SUPPLEMENTARY ASSESSMENT MEMO

Panel Reference	2018STH013
DA Number	DA/0276/1718
LGA	Goulburn Mulwaree Council
Proposed Development	Remediation of contaminated soil and groundwater and demolition of structures on the former Goulburn Gasworks site & adjacent foreshore area
Street Address	1 Blackshaw Road, Goulburn NSW 2580
Applicant/Owner	Jemena Gas Networks (NSW) Ltd
Date of DA lodgement	23 February 2018
Number of Submissions	0
Recommendation	Conditional Approval
List all documents submitted with this report for the Panel's consideration	<ul style="list-style-type: none">▪ Stormwater concepts plans 21-25081-C001 and C002 (attached to email sent with report to JRPP)▪ Appendix G Demolition of Structures, prepared by Jemena, dated 23/02/2018▪ Drawing 207036-A02 in ground retaining walls (attached to email sent with report to JRPP)
Report prepared by	Chris Hargood – Senior Development Assessment Officer
Report date	17 August 2018

DA/0276/1718, 1 Blackshaw Road Goulburn, Remediation of contaminated soil and groundwater and demolition of structures on the former Goulburn Gasworks site & adjacent foreshore area

drawing title
**SITE PILING
DESIGN AND DETAILS**

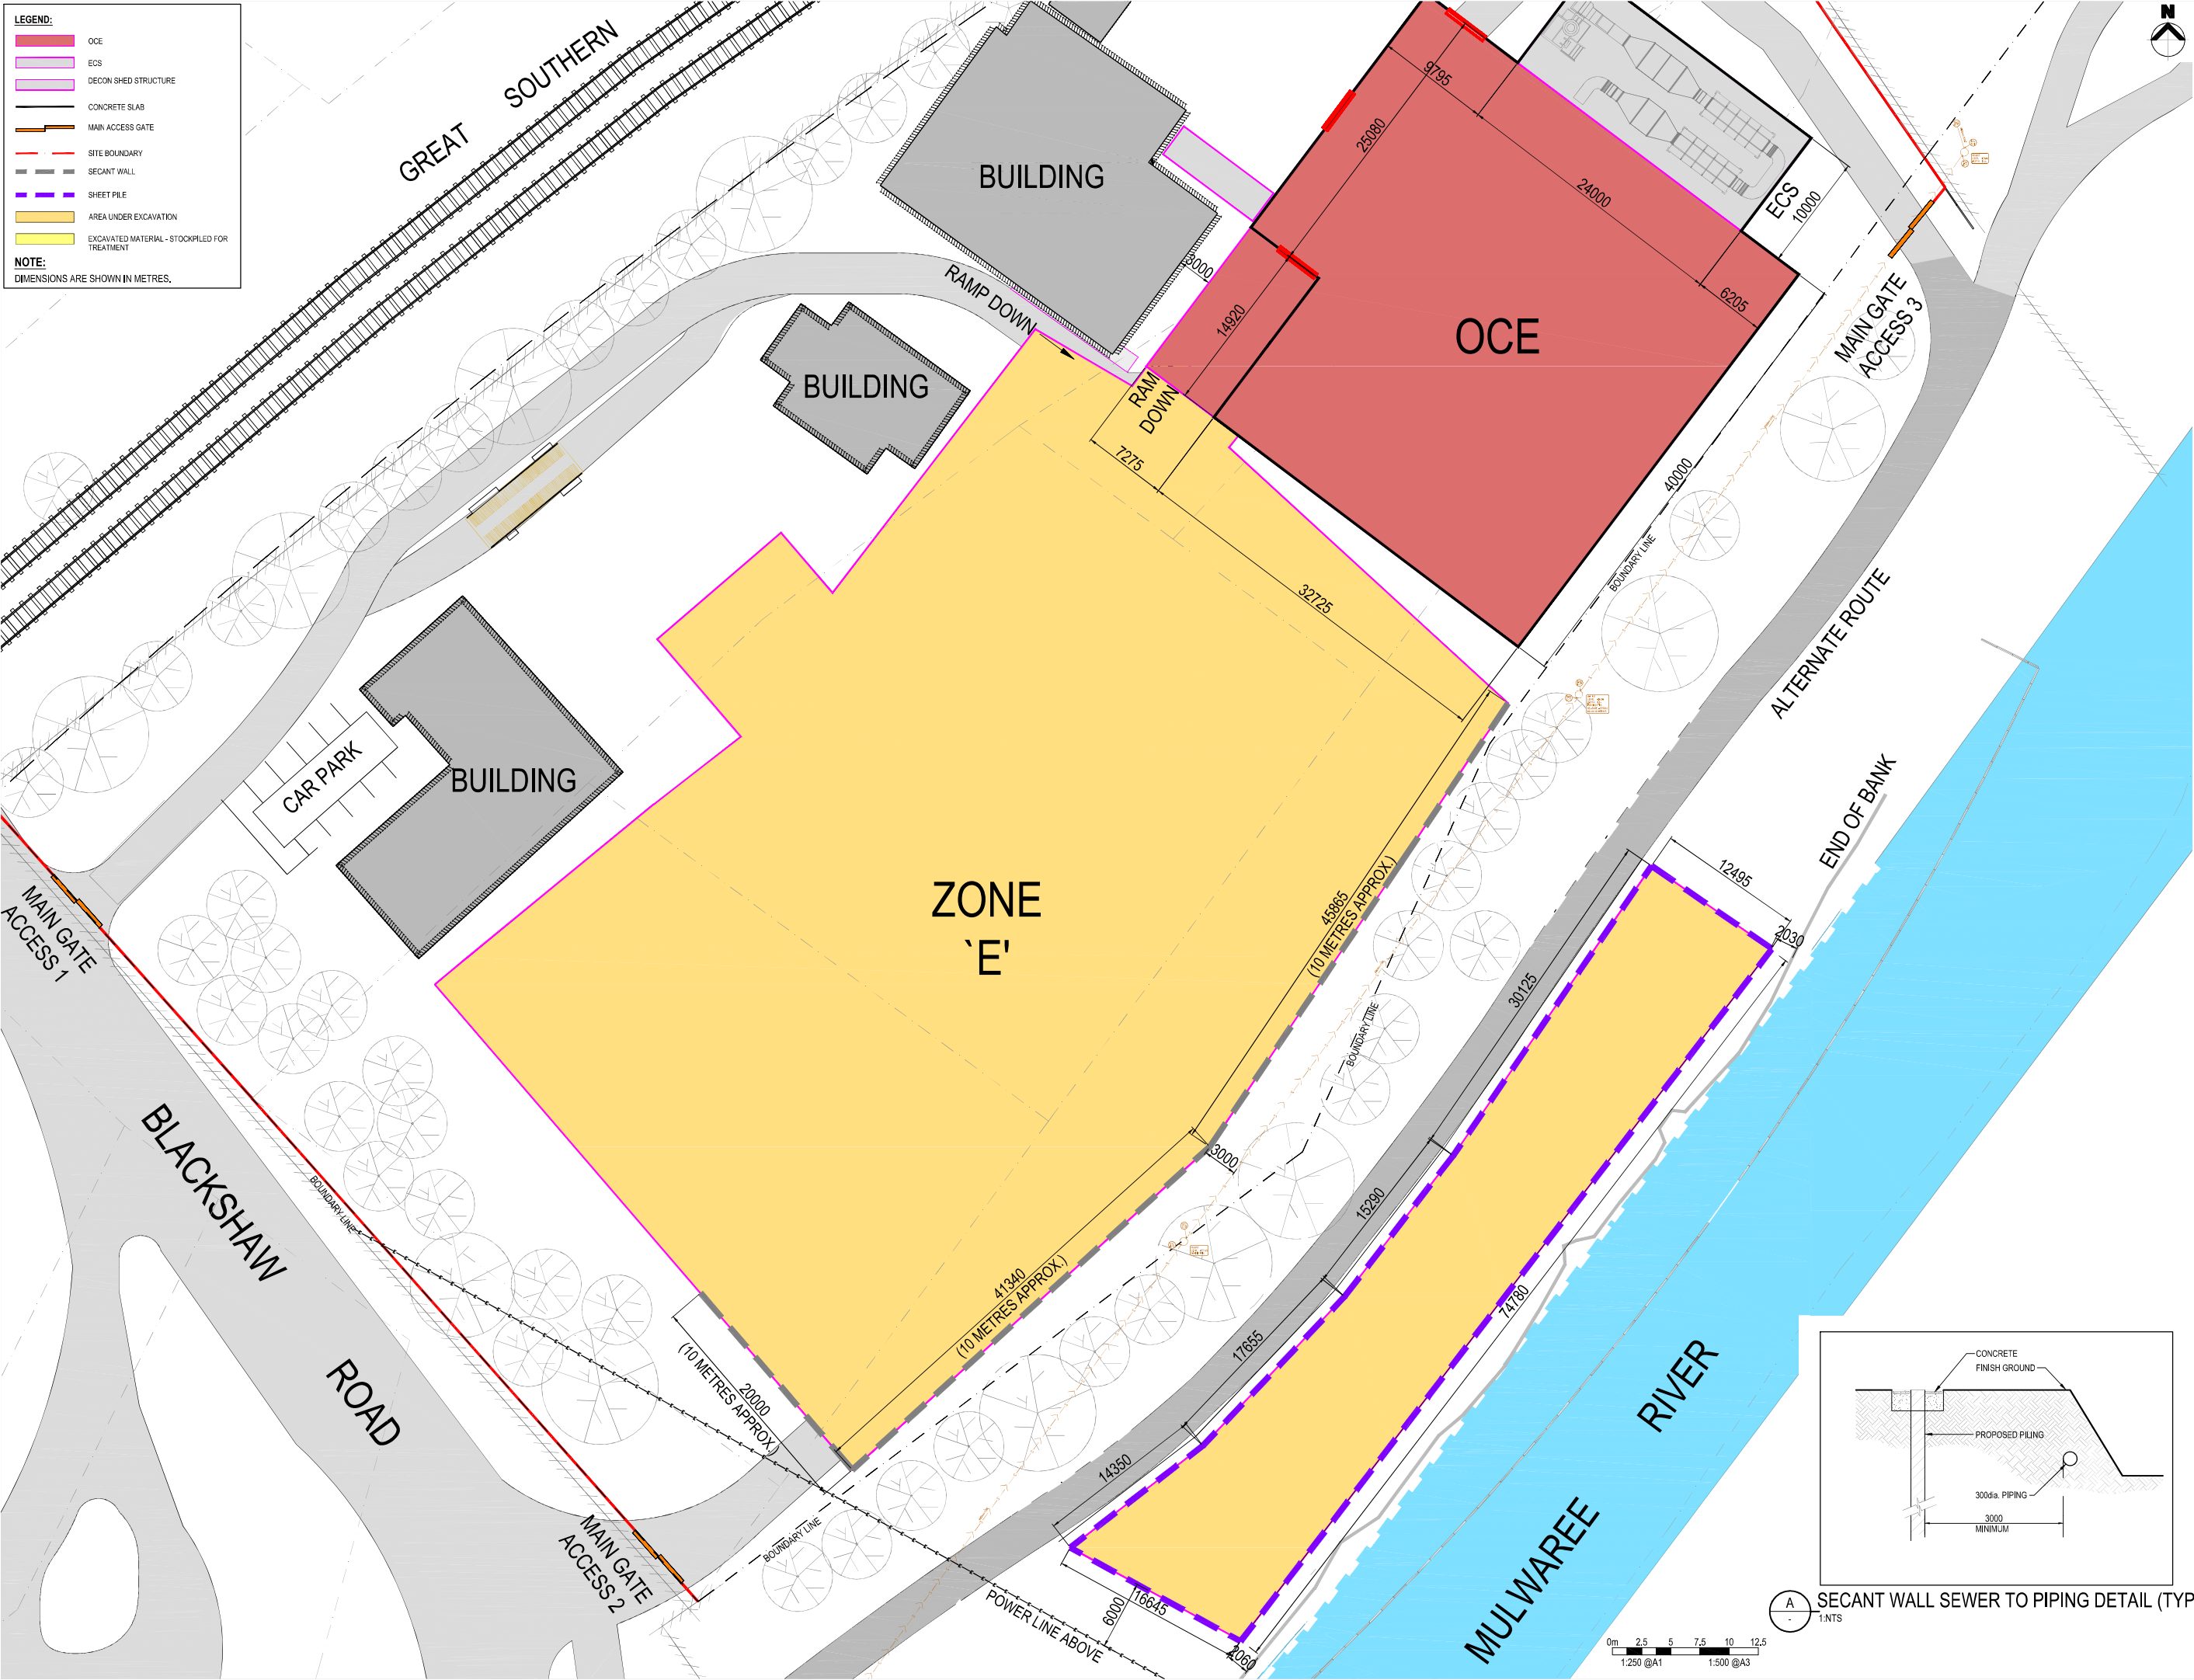
- 5. Please provide details of retaining wall structures and where they are going - referred to in the report**

The report identified retaining wall structures to be sub-soil in ground walls located behind the embankments, the location and design of the sheet piling walls are depicted on drawing 207036-A02, a copy of the plan is attached to this memo.

Figure G2–1: Location of Structures to be Demolished

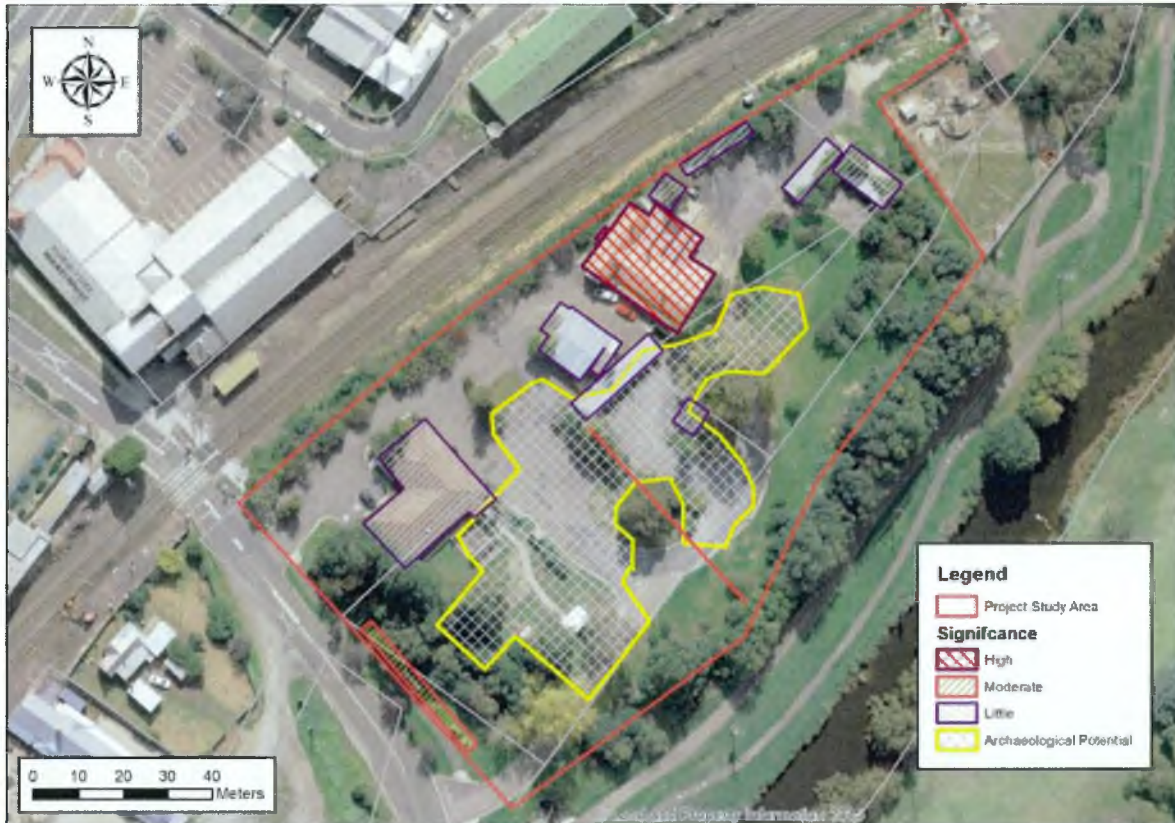
- 4. Please attach the plan that shows which buildings are being demolished - referred to in the report**

The buildings identified to be demolished have been identified in Appendix G of the Statement of Environmental Effects; Appendix G provides an overview plan of the structures to be demolished along with identification photos of the individual buildings to be demolished. Appendix G has been extracted from the Statement of Environmental Effects and attached to individually to this memo.
